MIAMI BEACH, FLORIDA	
SURFSIDE WORK CENTER	
SOUTHERN BELL TELEPHONE AND TELEGRAPH CO.	
W. KENYON DRAKE & ASSOCIATES - ARCHITECTS	
237 WEST FORBETH STREET JACKSONVILLE, FLORIDA	
DATE: MAY 1966	53
6619	
MARK: E.M.C.	
INDEX: T.E.P.

PLAN REVIEW NOTICE SURFSIDE, FL 33141

PLANS PROCESSING APPROVALS

SURFSIDE SOC WORKCENTER

GLC NO. M6213
DRAWING NO. E1010D
SHEET 02 OF 6

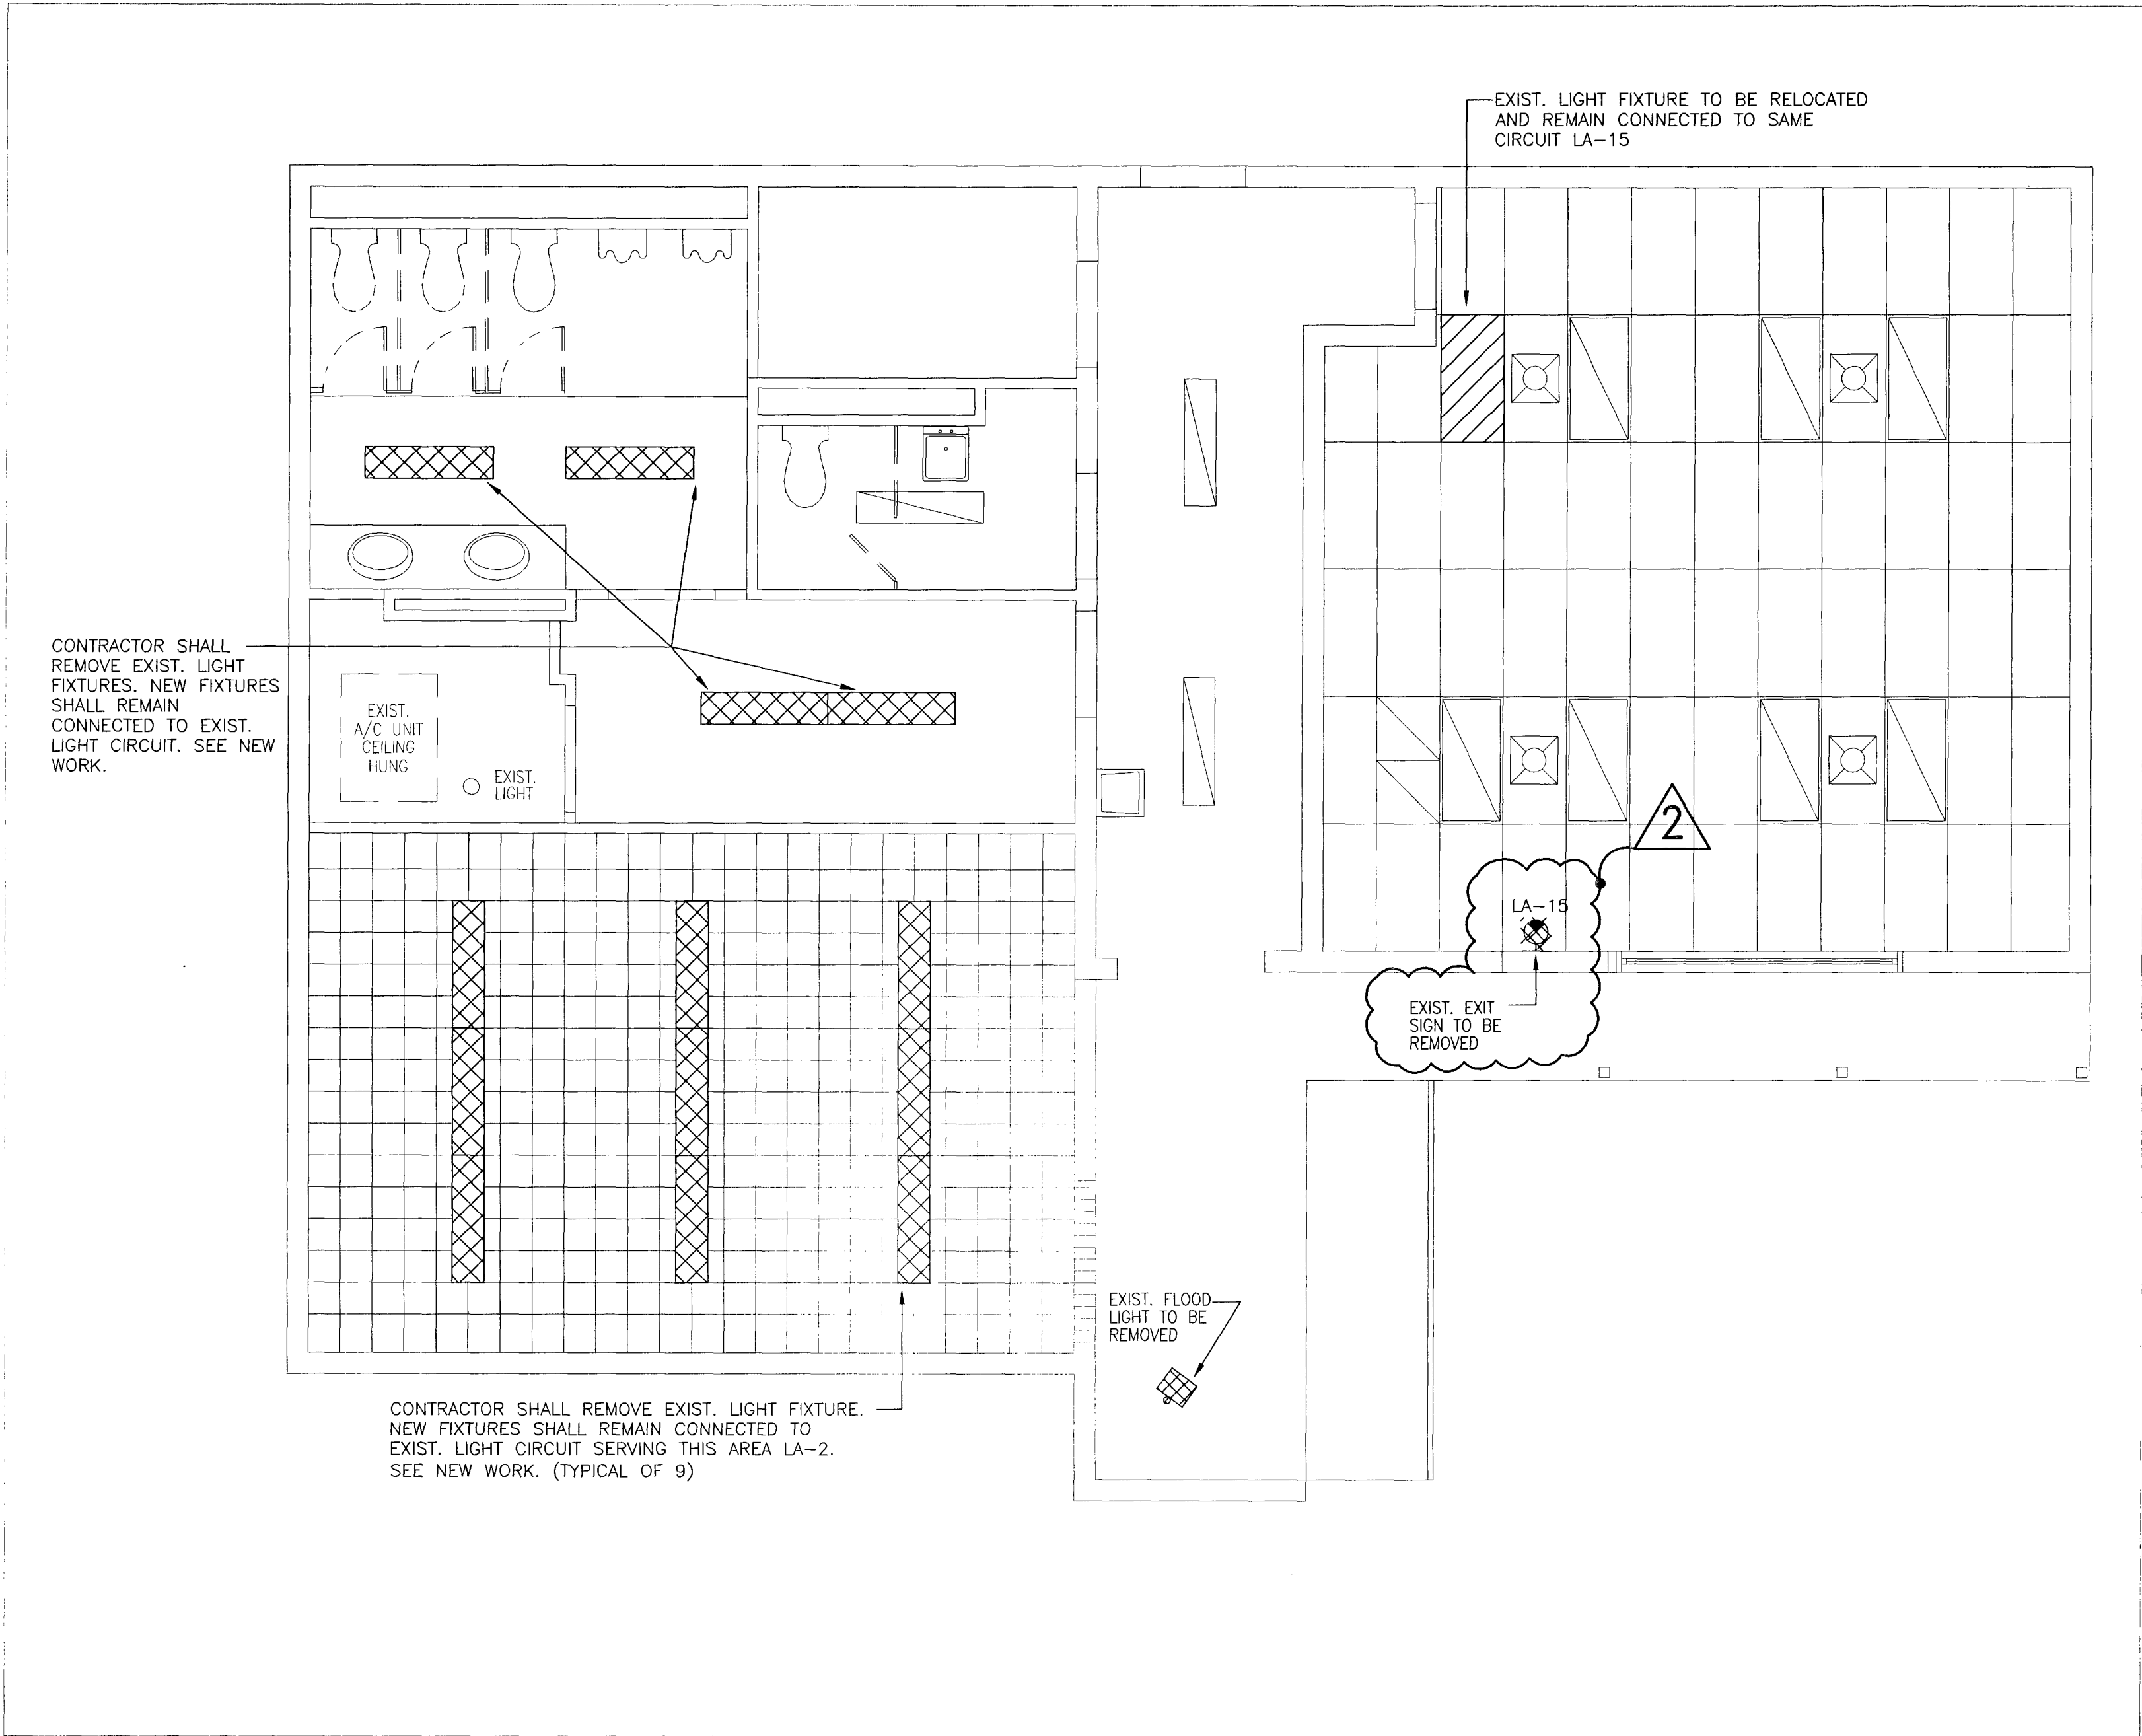
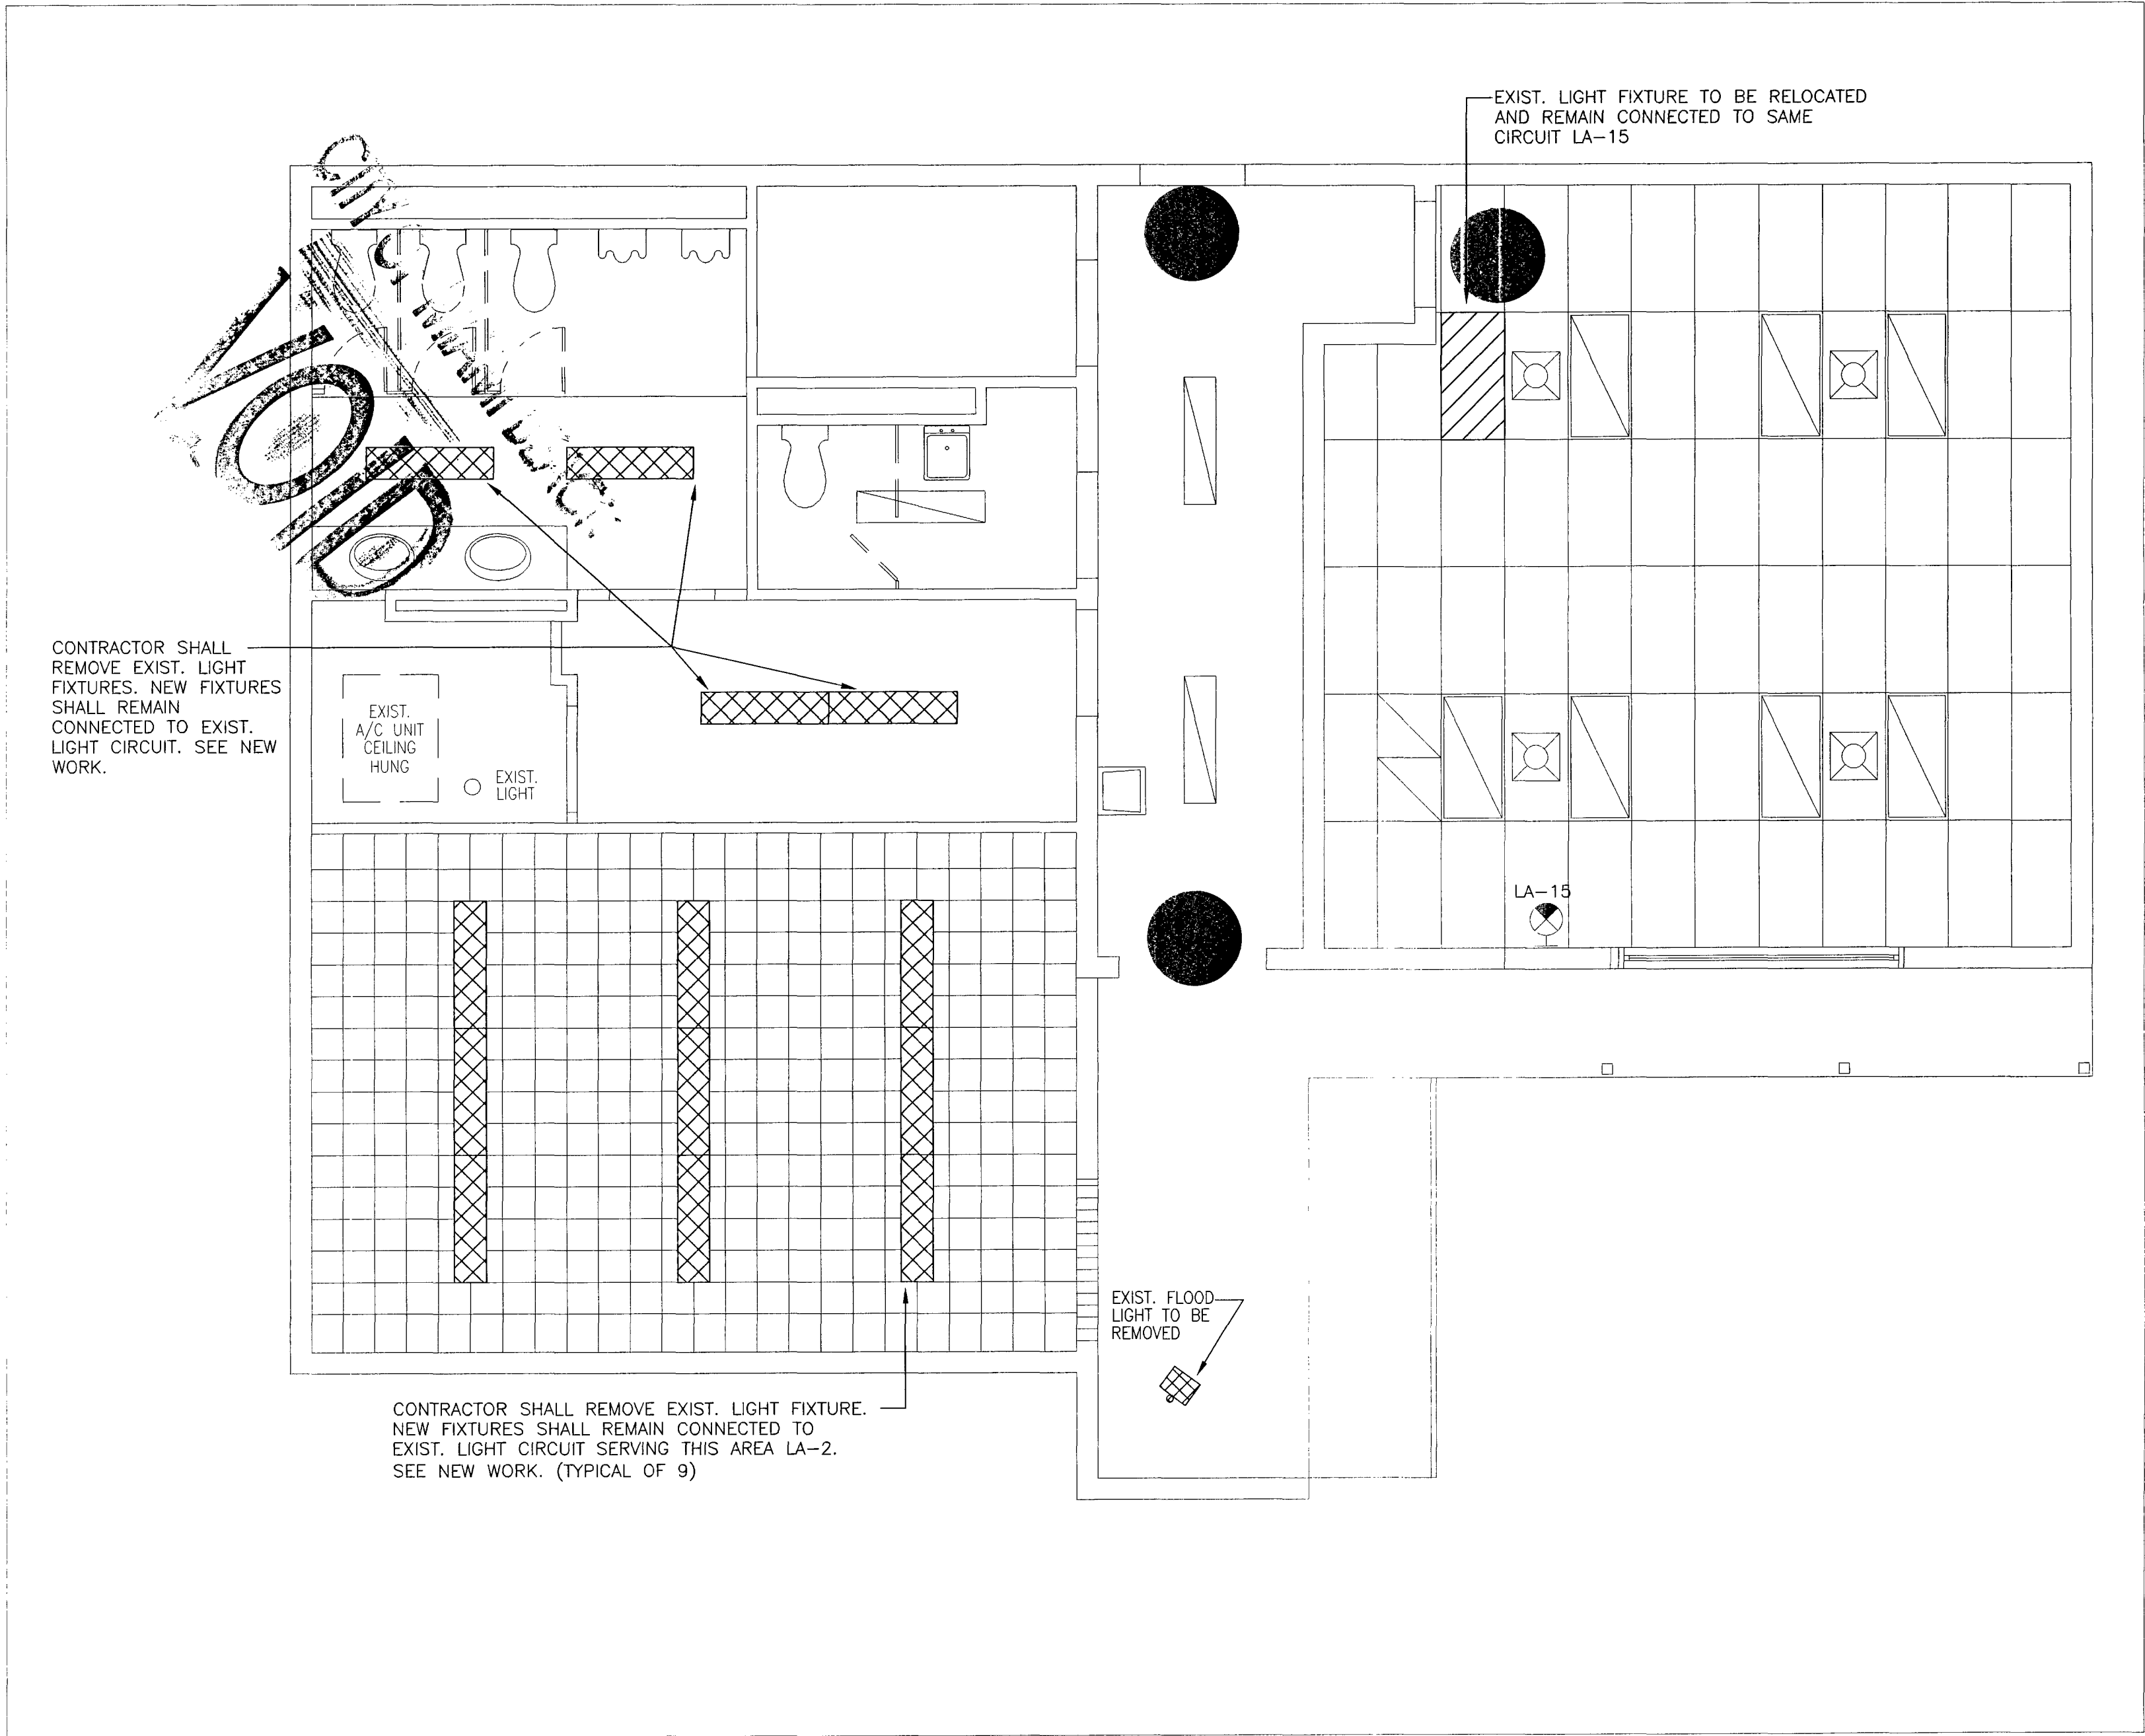
sheet e1010d:

1. provide additional exit signs in green dotted areas
2. show emergency lighting
3. show all systems (fire alarm sprinklers etc) if applicable
